**SECTION 00 9112 - ADDENDUM NUMBER 2**

**1.02 PROJECT: GENERAL CONSTRUCTION INDEFINITE DELIVERY CONTRACT (MCKISSICK MUSEUM BATHROOM RENOVATIONS)**

**1.03 OWNER'S PROJECT NUMBER: H27-D259-CB**

**5.01 DRAWING S101 - GENERAL NOTES, OVERALL PLAN AND DETAILS**

sheet number  
**S101**

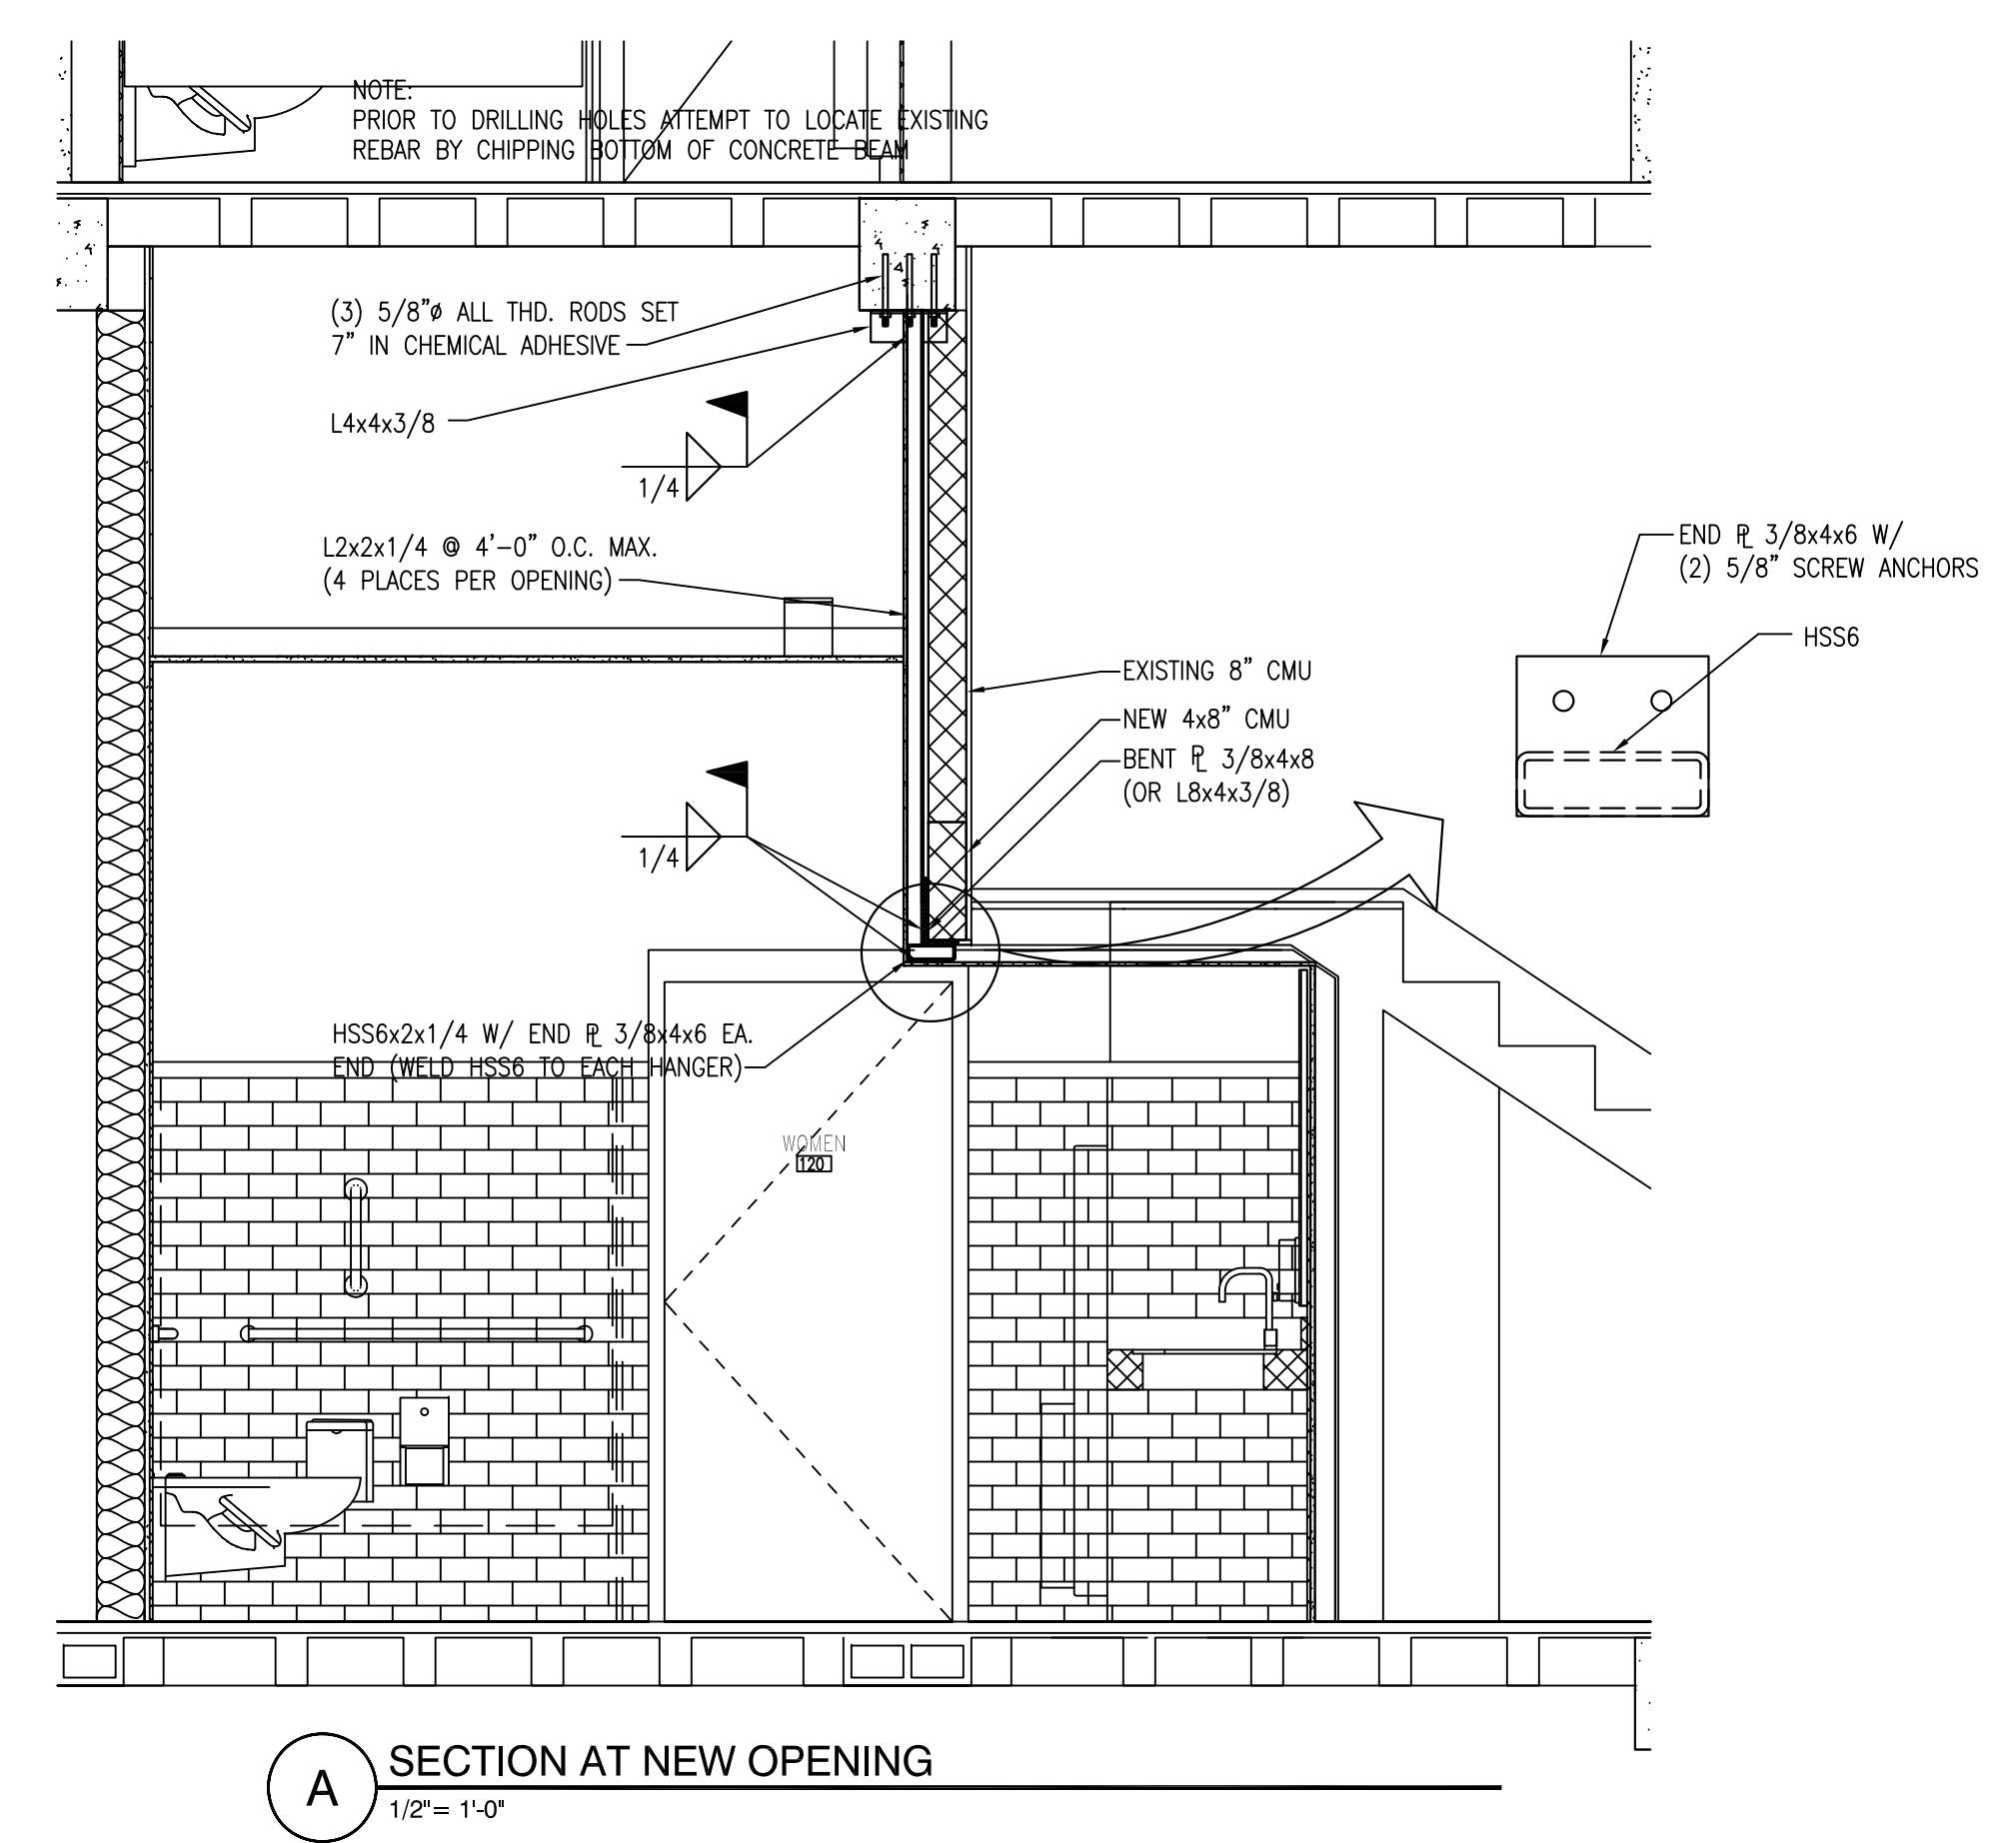
- A. Replace existing drawing S101 with the revised drawing S101 attached.
- B. Corrected the location of the tag for detail A and removed detail B from the drawing.
